**DOT/FAA/ND-00/1**

# **Heliport/Vertiport Design Deliberations 1997 - 2000**

14. Sponsoring Agency Code	
15. Supplementary Notes					
16. Abstract  During the last several years, the FAA has been working toward the revision of both the Heliport Design advisory circular, AC150/5390-2B, and the Vertiport Design AC, AC150/5390-3. This work has been done in cooperation with Industry via meetings, discussions, and working papers. This report documents some of the some of the more significant issues that have been discussed during the 1997 to 2000 time period.  While heliports and vertiports are different, many of the design issues are similar. Indeed, the FAA has previously announced its intentions to combine the two advisory circulars (AC) into one AC. This is why both subjects are addressed in the same report.

Figure 1. Comparison of the Current 1 : 8 Approach/Departure Surface and the Two - Slope Approach/Departure Surface (Two Approach/Departure Paths)

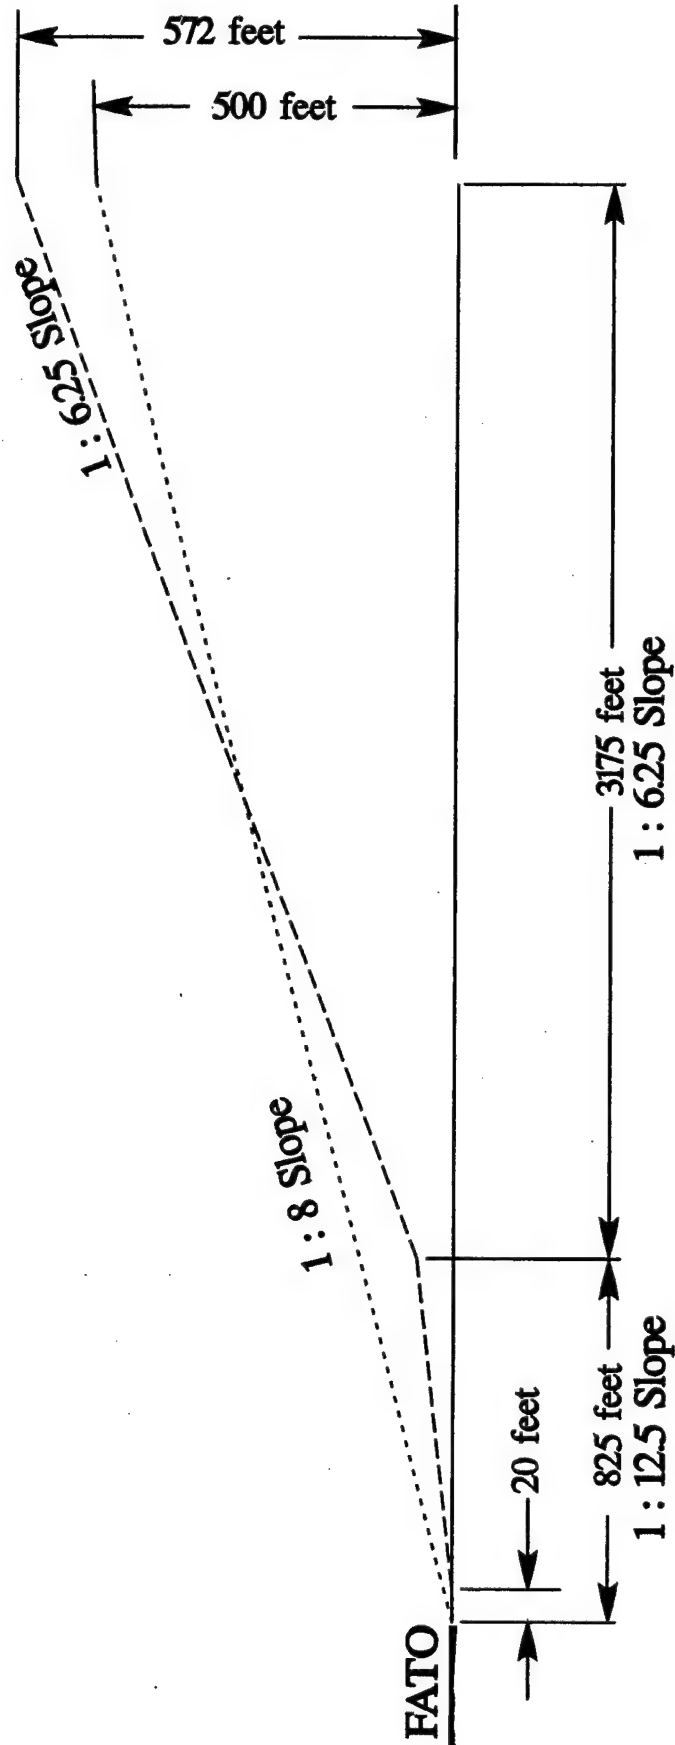
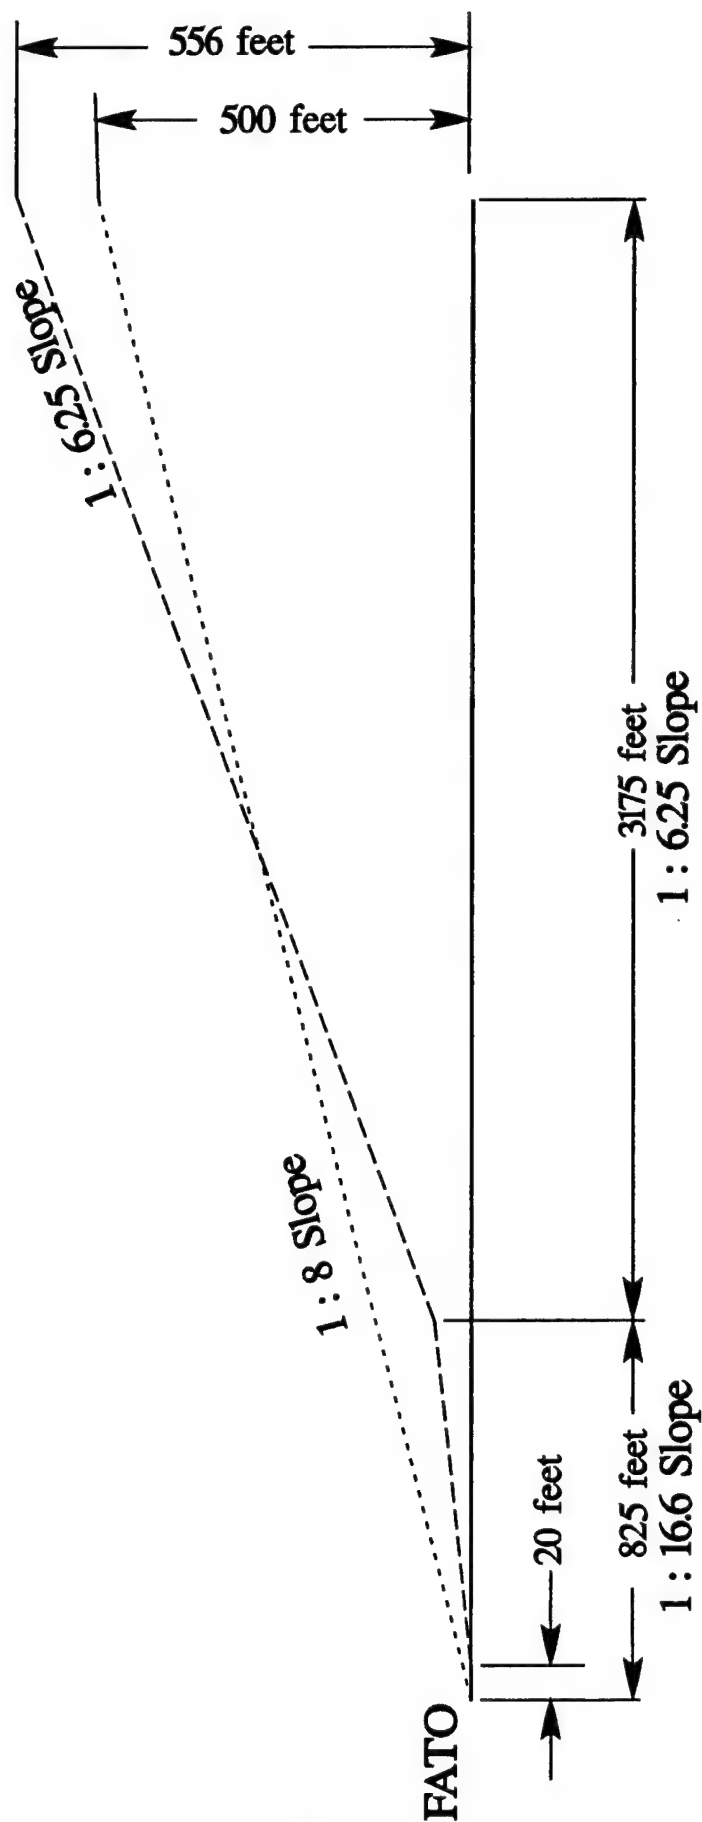
Subsequently, Industry has proposed that AC150/5390-2B be modified to require only one approach/departure path at certain heliports and that Figure 1 should also apply in such cases. This is an unappealing proposal. Transport Canada's rationale for distinguishing between these two scenarios is sound; it is a simple matter of physics. Helicopter performance deteriorates in the presence of a tailwind. At a heliport with only one approach/departure path, the pilot will sometimes be forced to operate with a tail wind. To maintain an adequate safety margin under such a scenario, the additional airspace of Figure 2 is appropriate.

The FAA would strongly prefer to adopt both figures 1 and 2 as Transport Canada has done. Figure 1 would be for heliports with two approach/departure paths (separated by 150 degrees or more). Figure 2 would be for heliports with only approach/departure path. Unfortunately, we have been unable to reach a consensus on this point with Industry. As a compromise, the FAA and Industry have agreed to adopt figure 1. While this is less than ideal, it does provide an additional safety margin in comparison with the current Heliport Design AC recommendations. This additional airspace would also provide operators with additional operational flexibility.

Figure 1. Side View of the Airspace Wherein  
Marking and Lighting are Recommended

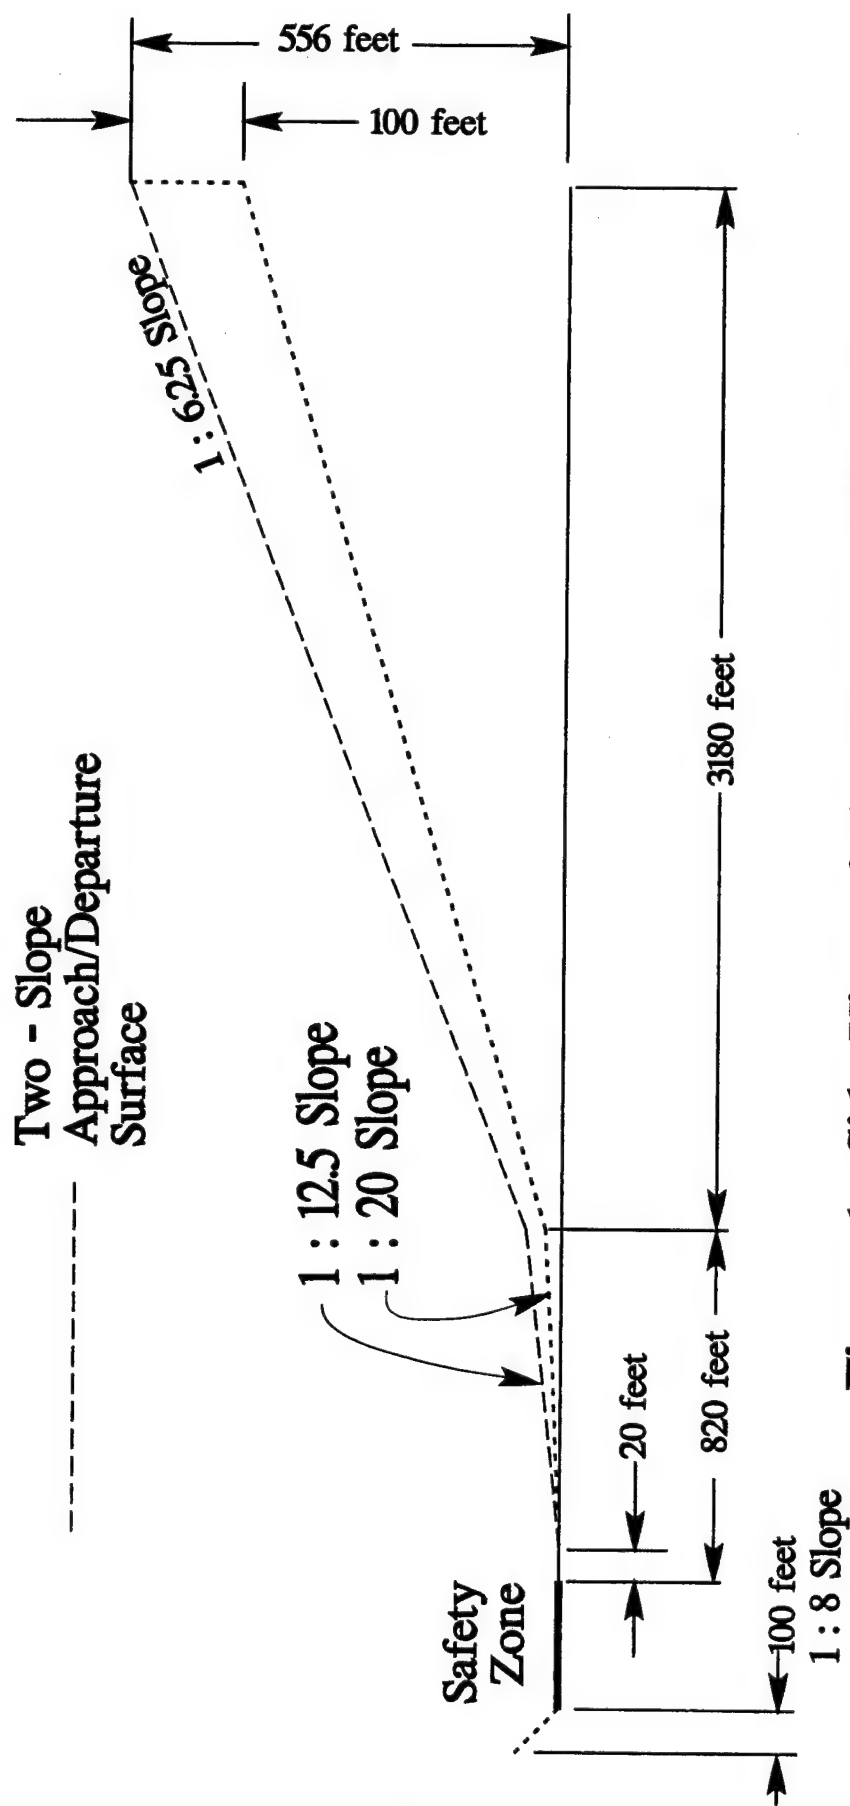
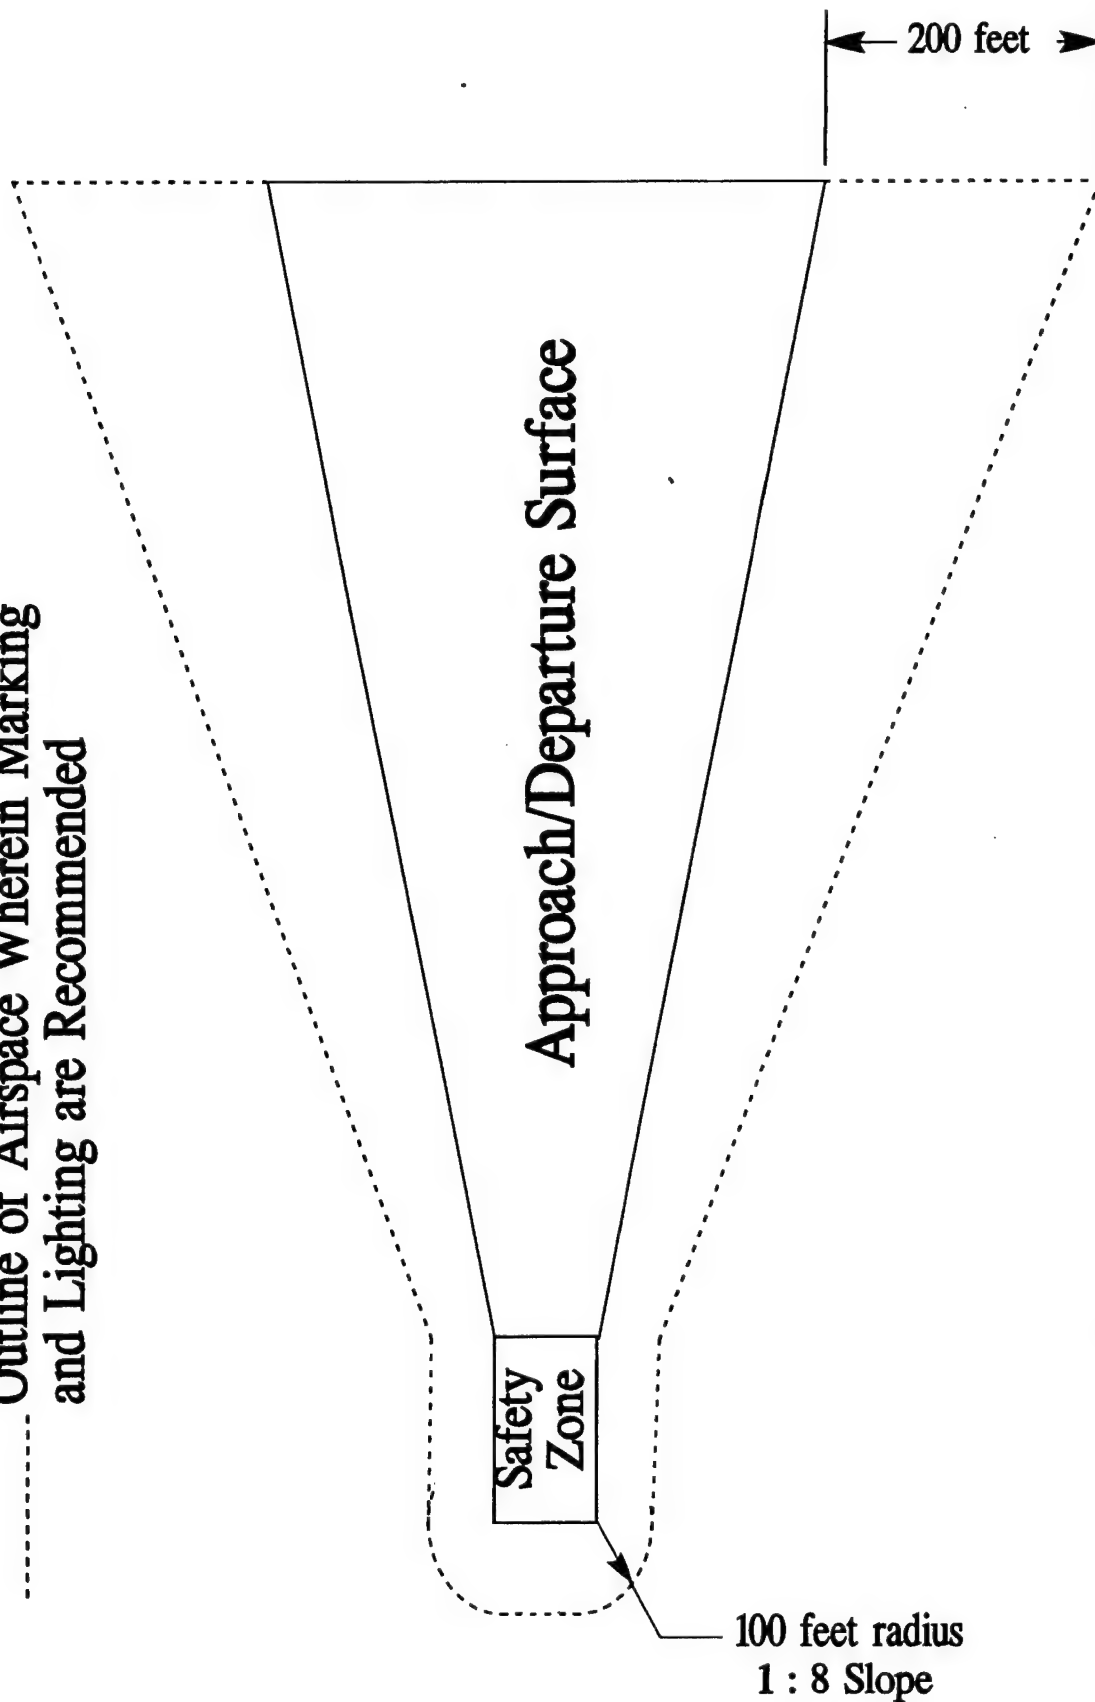
**Proposed Changes in Horizontal Dimensions of the VFR Approach/Departure Surface.** The proposed revision of the minimum recommended VFR heliport approach/departure surface was defined in the draft AC150/5309-2B. However, at this point, it appears appropriate for the FAA to postpone plans to revise the horizontal dimensions of this surface until a future revision. The revision of figure 3-14 (from the spring 1998 draft of AC150/5390-2B), shown below in figures 1 and 2, is based on the assumption that the revision of AC150/5390-2B will contain no significant changes in the horizontal dimensions of the VFR heliport approach/departure surface.

1. In the revised AC150/5390-2B, modify figures 2-14, 3-14, and 4-8 consistent with the attached Figures 1 and 2.
2. To avoid ambiguity in the revised AC150/5390-2B, the advisory circular text should discuss the various aspects of this airspace in greater detail, rather than simply referencing the figure as was done in AC150/5390-2A.
